AMENDMENT OF SOLICITATION/MODIFICATION OF CONTRACT			1. CONTRACT ID CODE N/A	PAGE 1 of 2
2. AMENDMENT/MODIFICATION NO. A002	3. EFFECTIVE DATE 07/09/08	4. REQUISITION/PURCHASE NO. N/A		5. PROJECT NO. (If applicable) WA FS ERFO 2007(1)-22(2) Mt. St. Helens District Repairs FR 83 MP 6.9 to 11.3
6. ISSUED BY Department of Transportation Federal Highway Administration 610 East Fifth Street Vancouver WA 98661-3801		CODE N/A	7. ADMINISTERED BY (If other than Item 6) CODE N/A	
8. NAME AND ADDRESS OF CONTRACTOR (No., street, county, State and Zip Code)			X	9A. AMENDMENT OF SOLICITATION NO. DTFH70-08-R-00023
CODE: N/A				FACILITY CODE: N/A
				10A. MODIFICATION OF CONTRACT/ORDER NO. N/A
				10B. DATED (SEE ITEM 13) N/A

**WA FS ERFO 2007(1)-22(2), MT ST HELENS DISTRICT EMERGENCY REPAIRS FR 83 MP 6.9 TO 11.3
GIFFORD PINCHOT NATIONAL FOREST, SKAMANIA COUNTY, WA**

REVISIONS ARE AS FOLLOWS:

STATE	PROJECT	SHEET NUMBER
WA	FS ERFO 2007(1)-22(2)	D.1

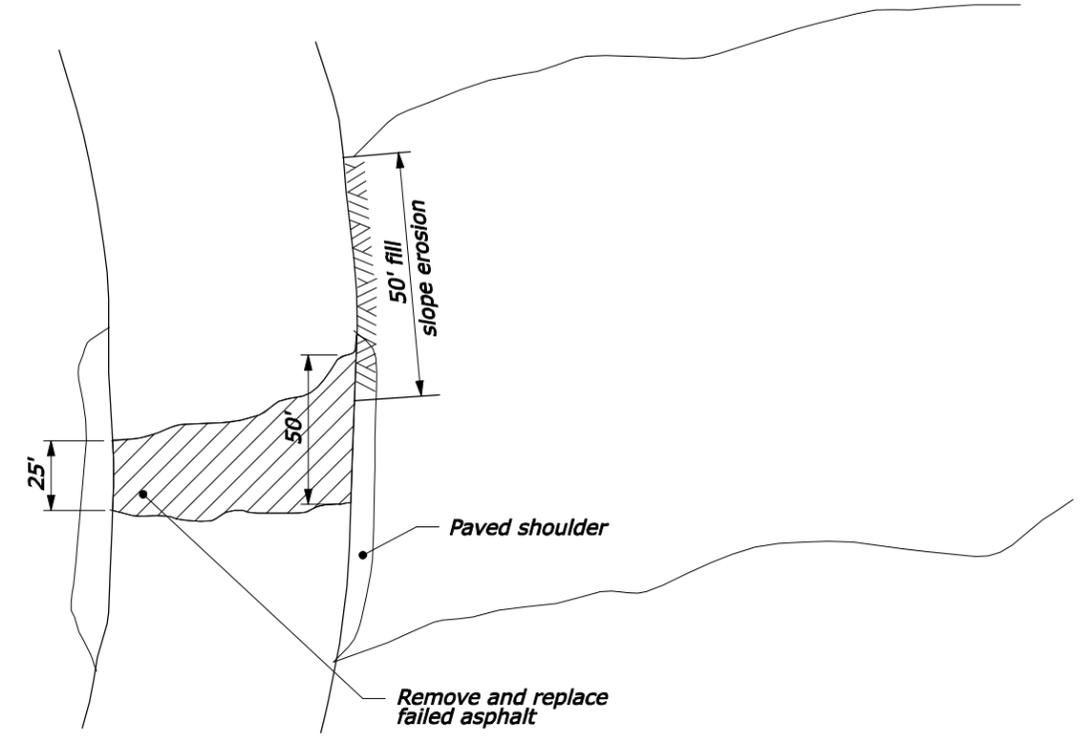
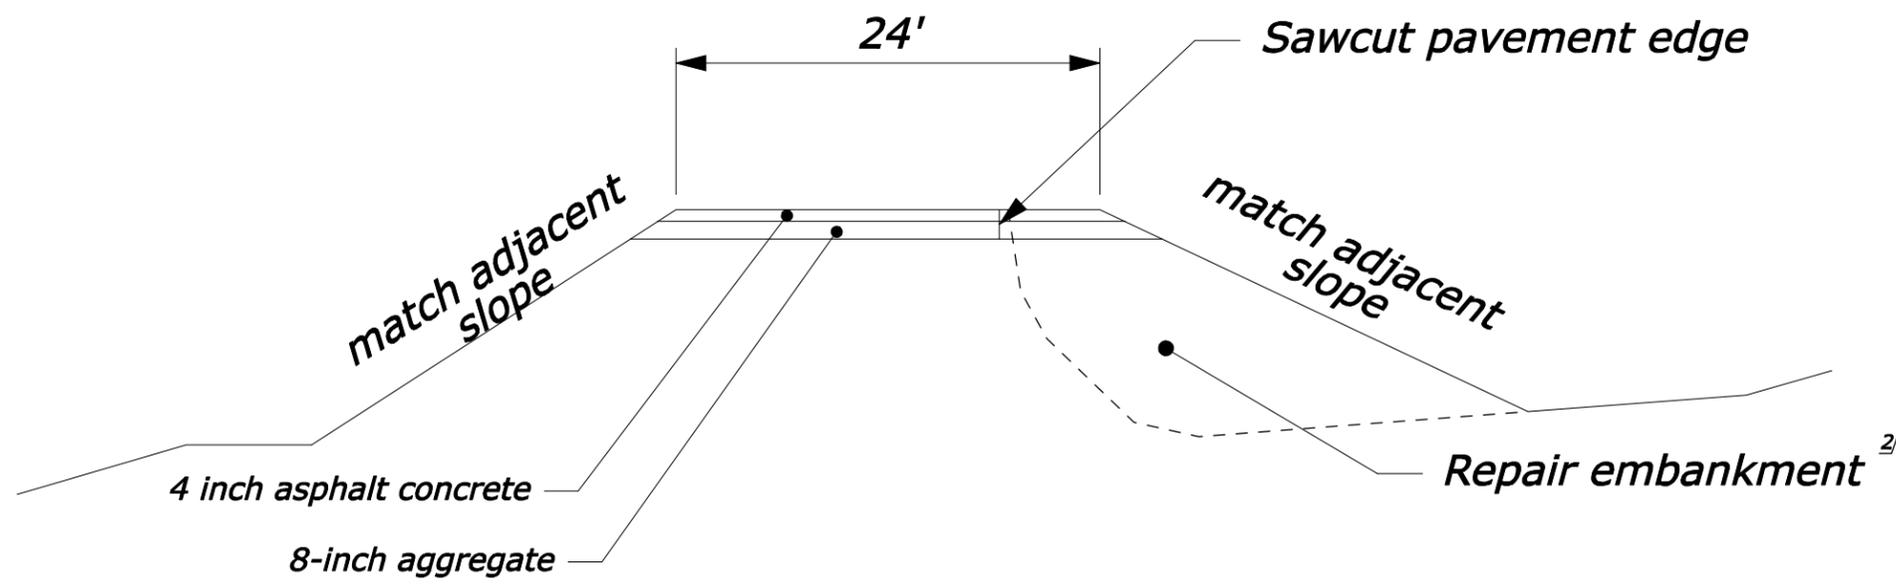
Plan sheet #D.1 Revises Estimated Quantities and Title
Plan sheet #E.1 Revises Estimated Quantities and Title
